Grahamvale BESS RFI Response Memorandum

Landscape Character and Visual Impact Assessment

Avenis Energy working on behalf of AE BESS 3

Re: Grahamvale Battery Energy Storage System (BESS) - Landscape Character and Visual Impact Assessment RFI

ZVI of 6m Acoustic Barrier

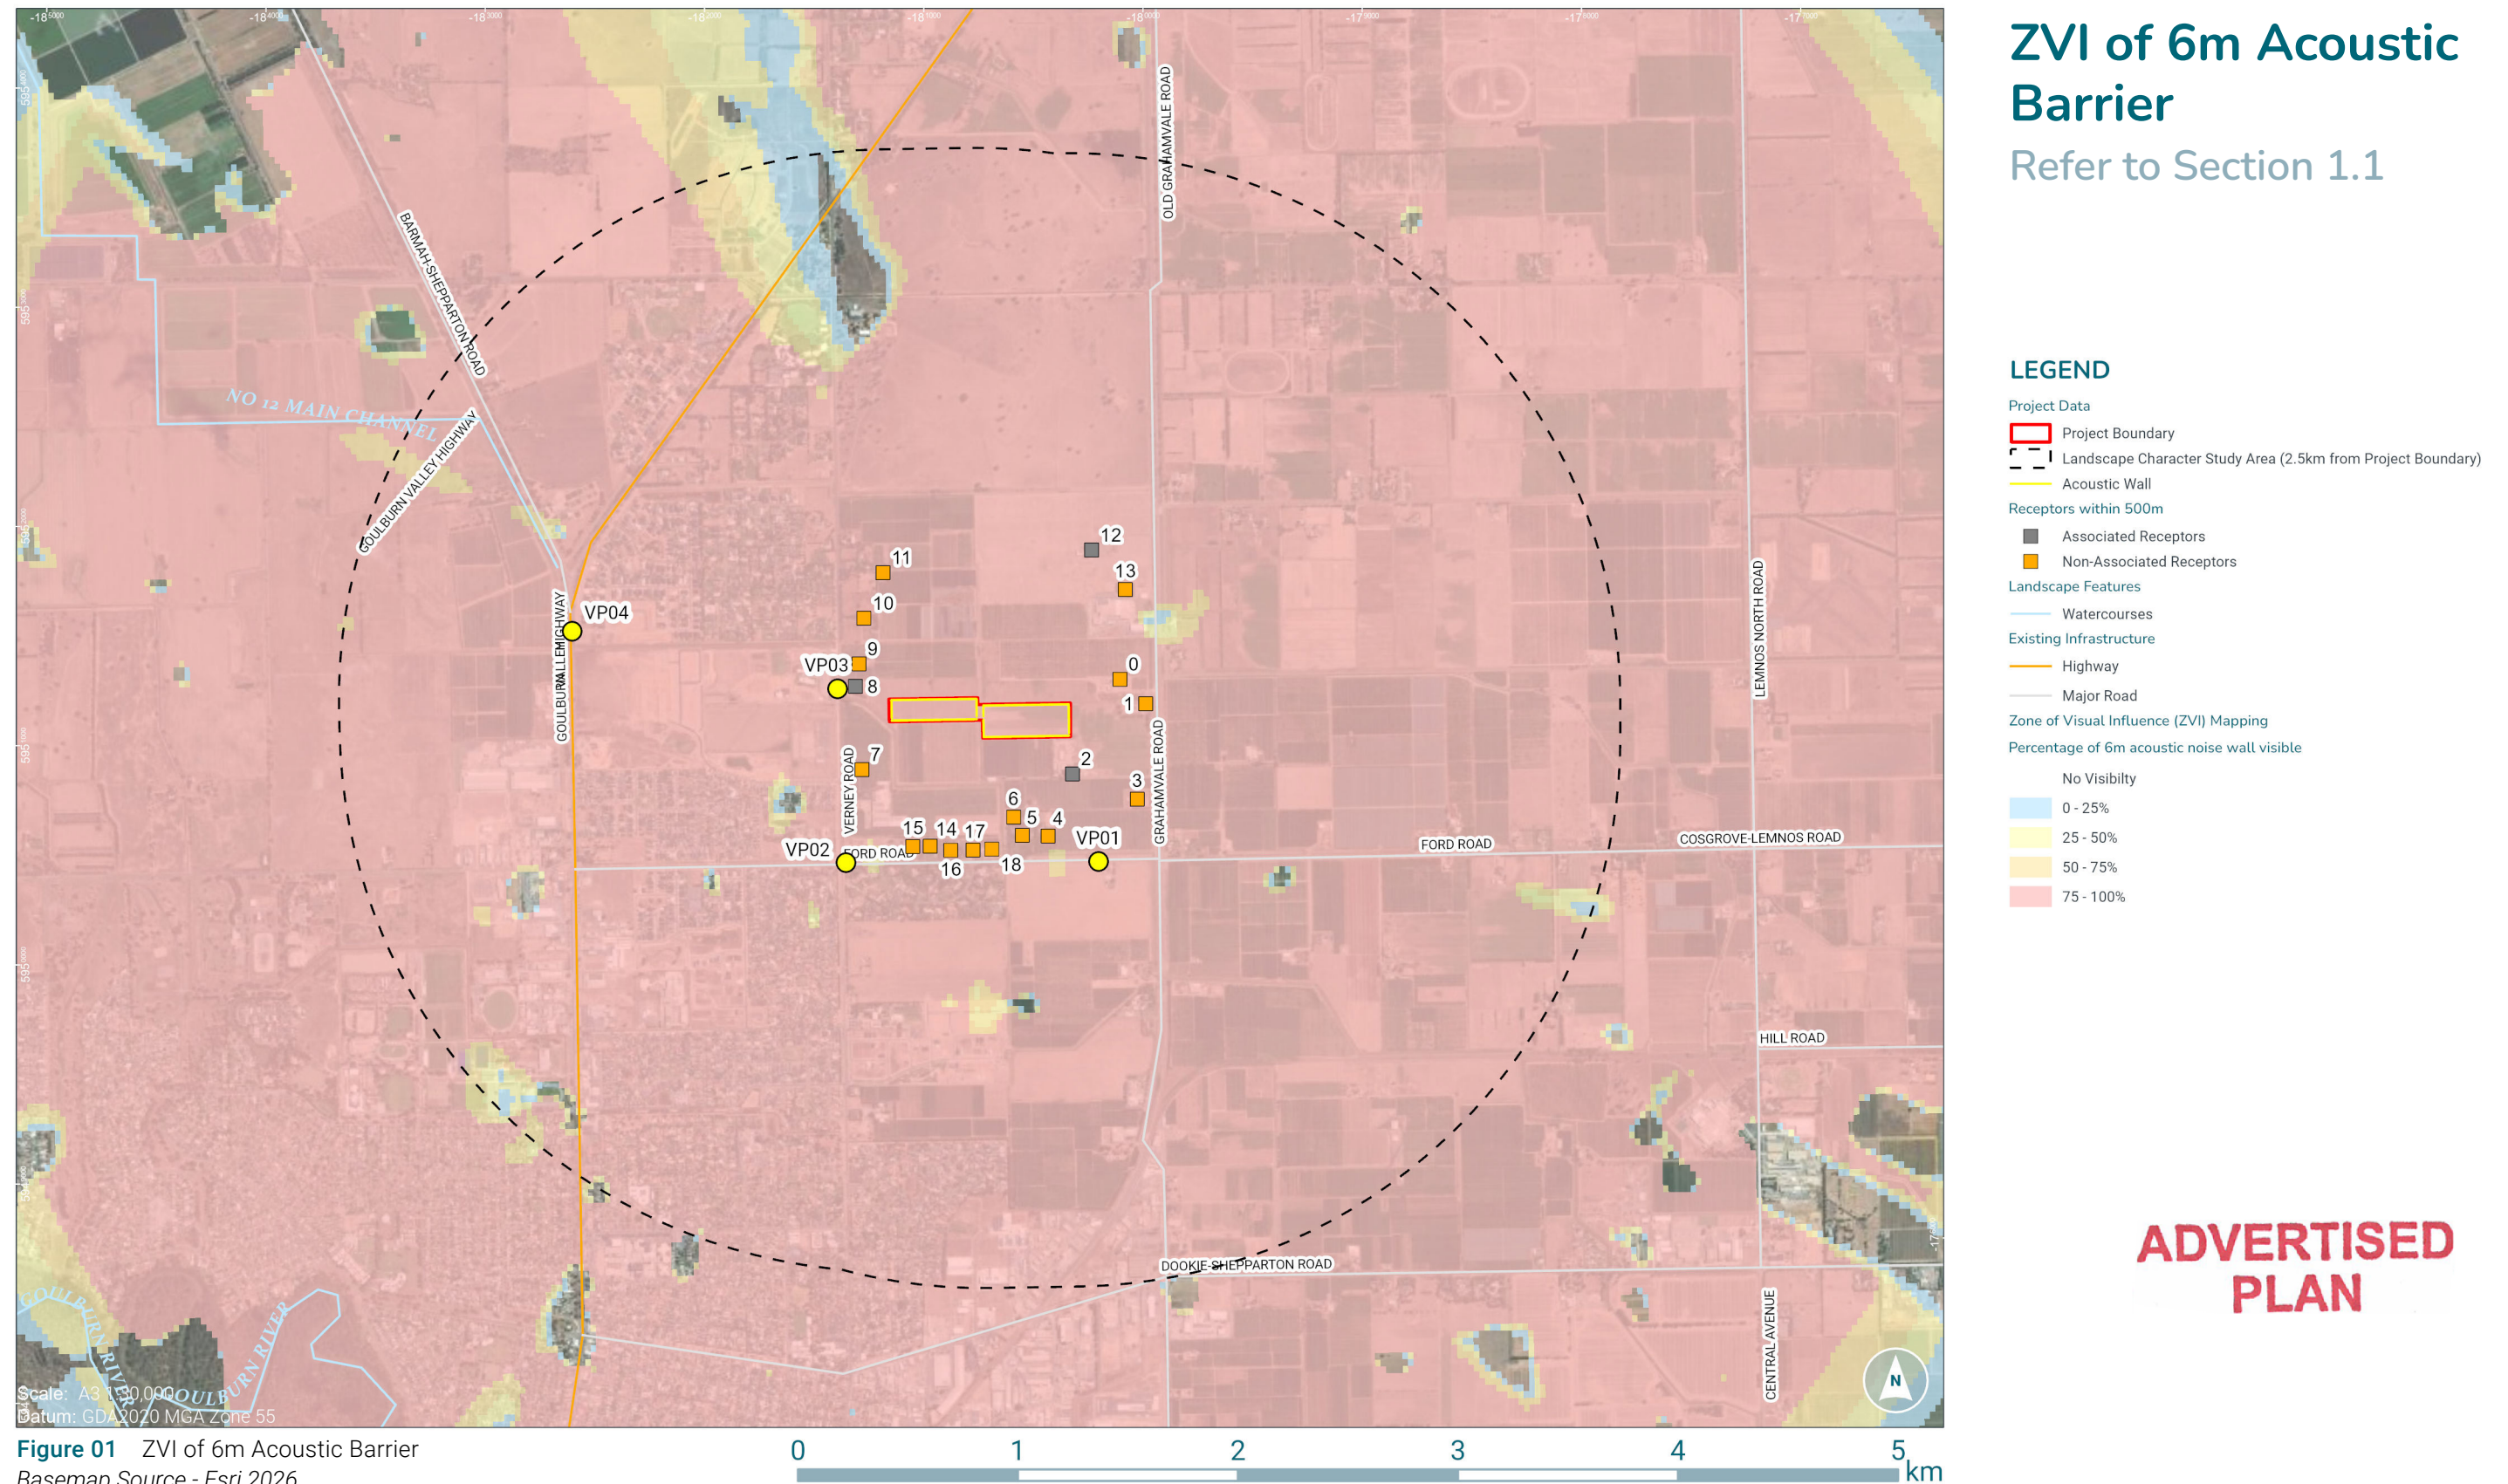
RFI - Assess the six metre acoustic barrier in the wireframe and include an assessment of its visual impacts on nearby sensitive receptors.

The ZVI for the Project has been prepared based on 6 m high Acoustic Walls surrounding the BESS modules, which occupy the majority of the Development Footprint. Results are shown in **Figure 01**.

- Due to the flat terrain, the majority of the roads and residences within the Study Area have potential theoretical views towards the project. However, it is noted that this analysis is based on topography only, and does not take into account existing screening elements such as built structures and vegetation. Further assessment of the extent of existing vegetation (screening elements) can be found in **Section 3.0**.
- 16 non-associated dwellings were identified within the street block surrounding the Project (the primary area from which direct views of the Project may reasonably occur), and with a theoretical line of sight. Further assessment of the extent of existing vegetation around non-associated dwellings can be found in **Section 3.0**.

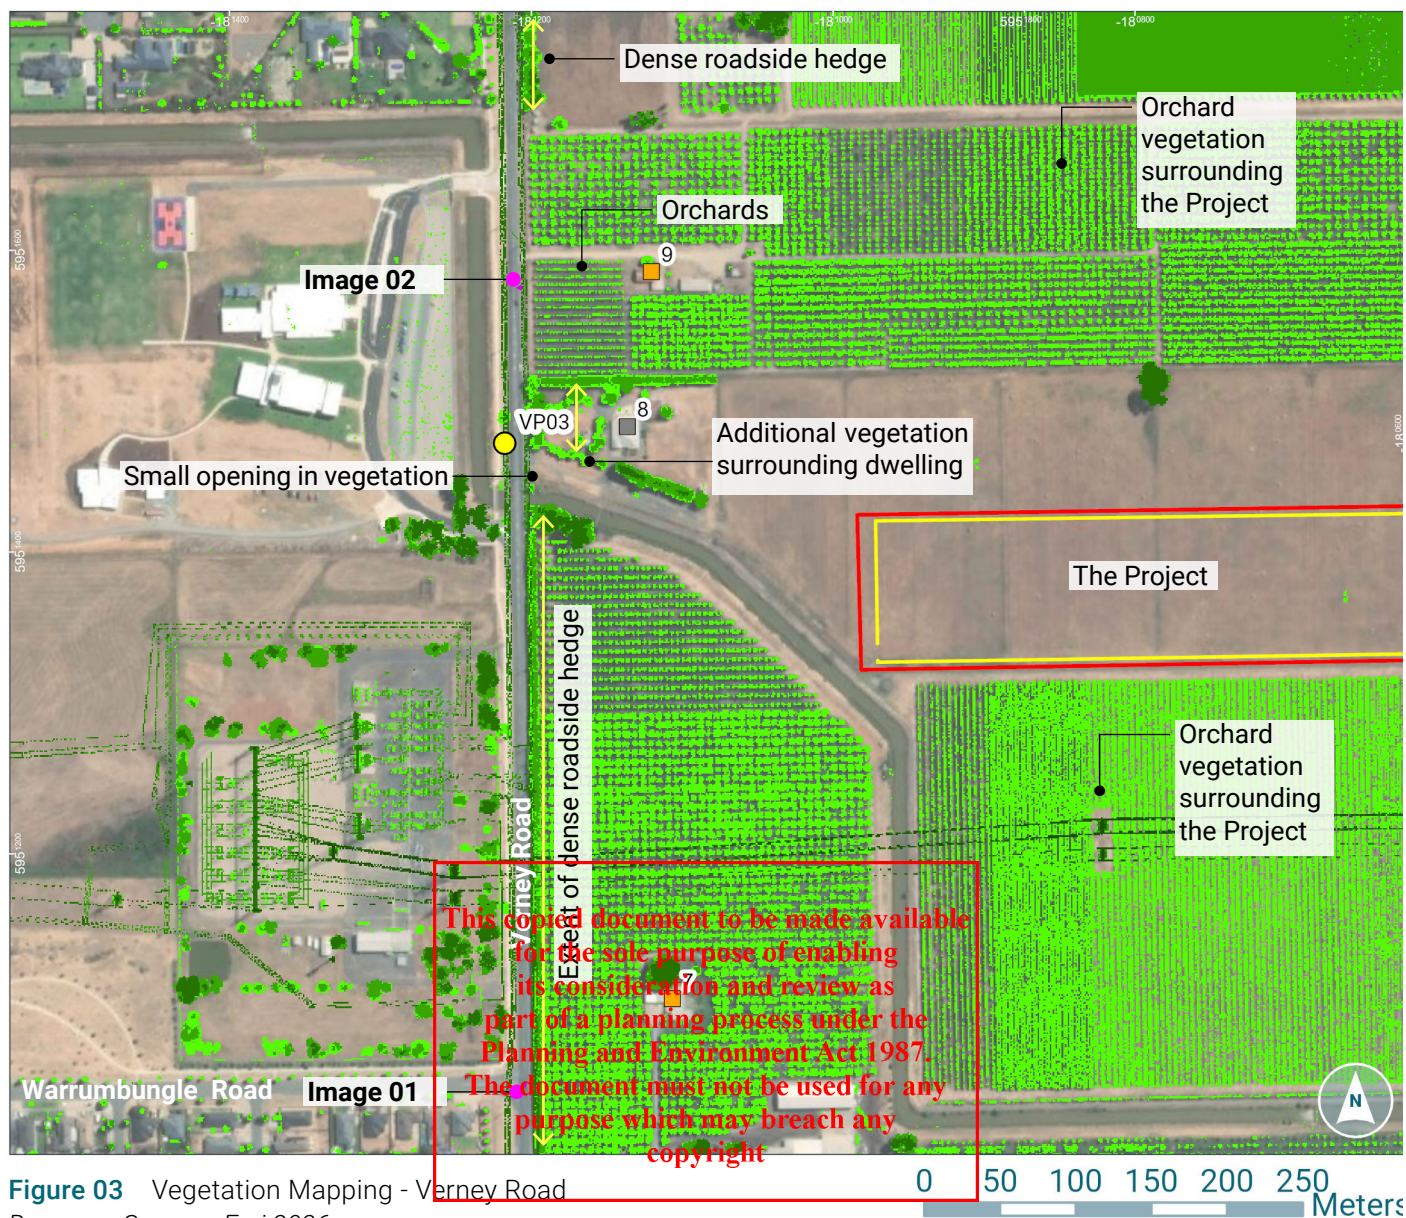
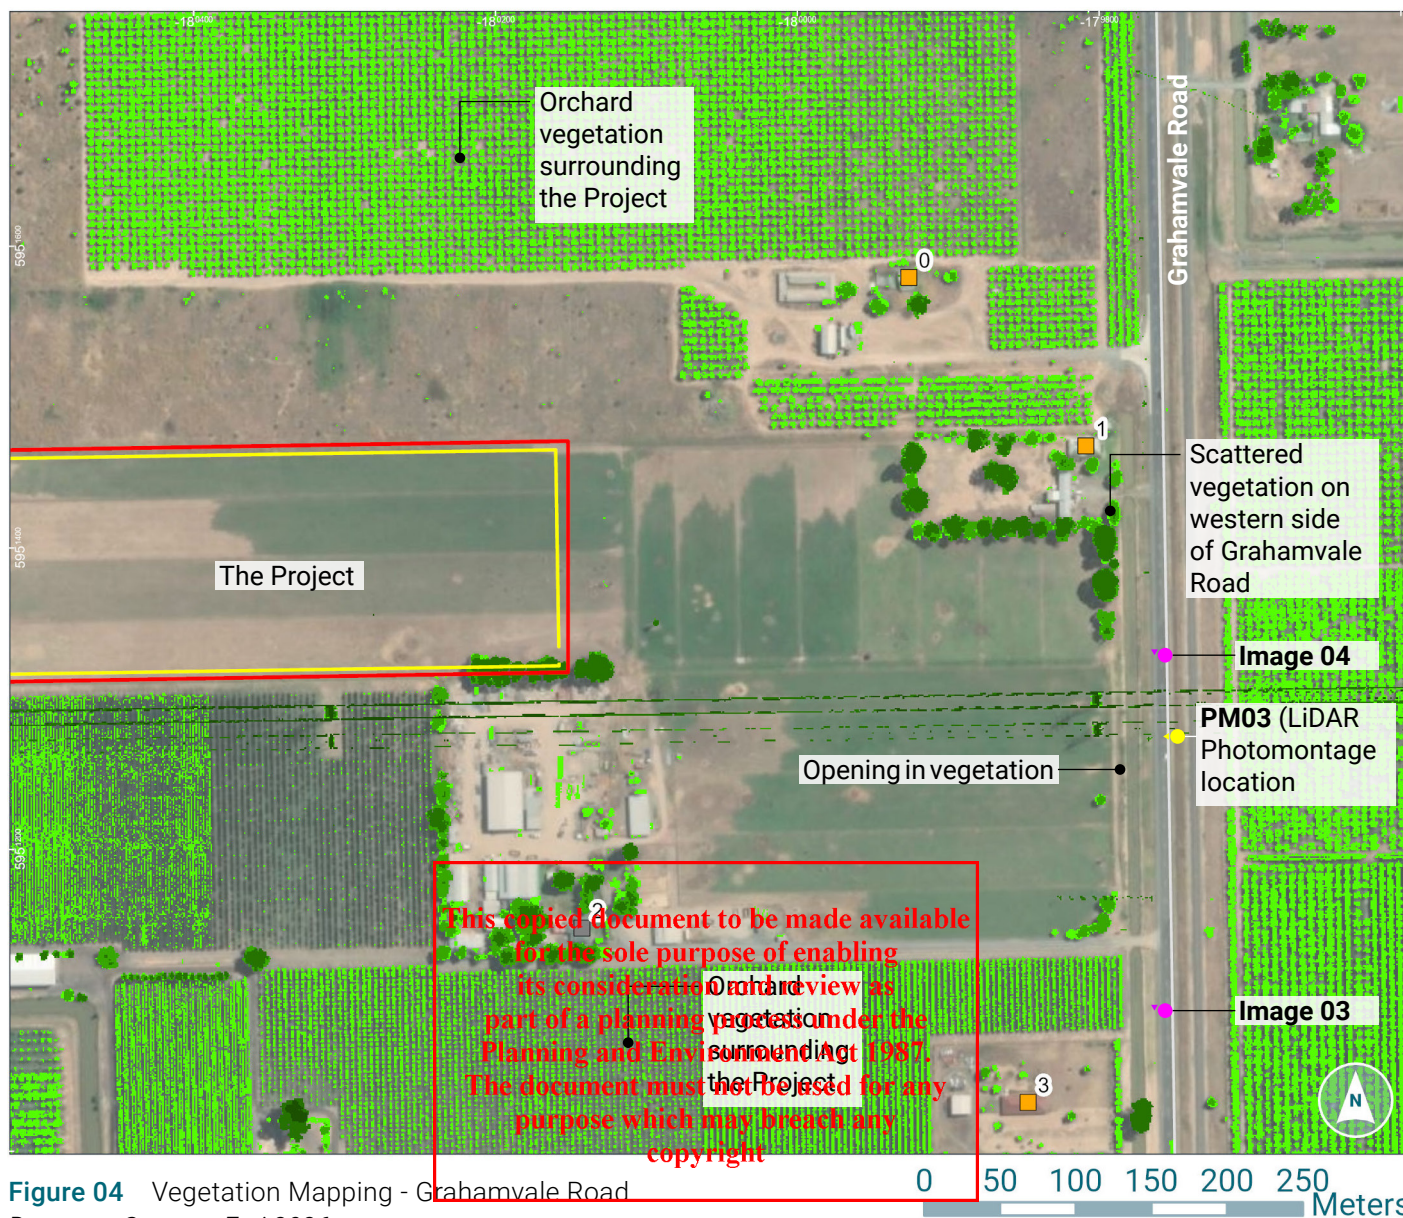
RFI - Justification for findings that the visual impacts are acceptable without any proposed on-site landscaping/vegetation screening.

- As **Figure 04** demonstrates, while the majority of Grahamvale Road is screened by vegetation associated with surrounding orchards and scattered roadside planting (refer to **Image 03** & **Image 04**), an approximately 400 m gap in vegetation allows for brief views of the Project. However, even without this screening, the Project is sufficiently set back from Grahamvale Road (approximately 400 m at its closest point) to appear only in the far background of the view. LiDAR visualisation PM03 (refer to "**Appendix A: Photomontages**") demonstrates that the proposed infrastructure is of a similar size and scale to nearby dwellings and agricultural sheds, while existing transmission infrastructure remains the dominant visual feature. Combined with the low sensitivity of road users, these factors result in a low visual impact.

Image 08 Vegetation gap on Verney Road #2 (viewpoint located south of PM02)

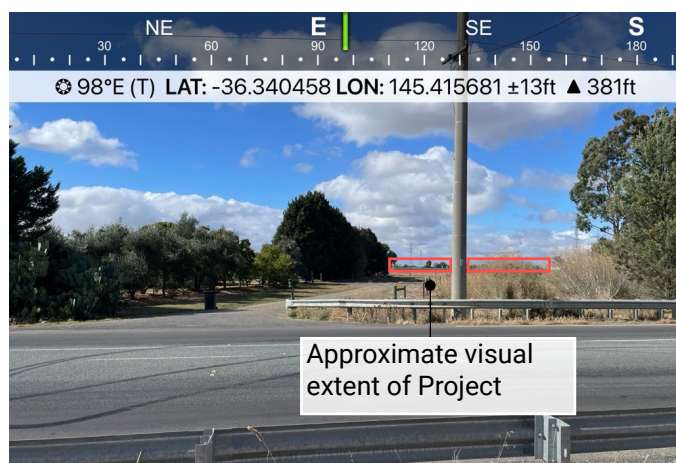
As the DPH RFI noted 'Viewpoint 3 (VP03) and Photomontage 2 (PM02) were provided in the Landscape and Visual Impact Assessment (LVIA). Viewpoint 3 (VP03) and Photomontage 2 (PM02) are taken from a location that places the development directly behind existing vegetation; however, immediately to the right / south of this location is noted in the LVIA as one which offers unobstructed views of the proposal from Verney Road. While it is considered that the LVIA is sufficient to assess impacts, it is our view that the LVIA could be more robust.'

The vegetation mapping in **Section 3.0** demonstrates that the Project will not be visible for the majority of Verney Road, with only a small 35 m gap allowing for brief views of the Project. While VP03/PM02 was taken at this location, the narrow viewing angle created by the gap means the Project remains partially screened by vegetation at the viewpoint. However, the viewpoint and photomontage still demonstrate that the size and scale of the Project, combined with the setback of the infrastructure from the road (approximately 200 m at its closest point), results in a low visual magnitude (refer to the wireframe and wireframe overlay included in PM02). Additionally, while gaps in vegetation may allow partial views of the BESS infrastructure from short sections of Verney Road (refer to **Image 07** & **Image 08**), viewer sensitivity is considered low due to the brief and transient nature of views experienced by road users, leading to an overall low visual impact rating.
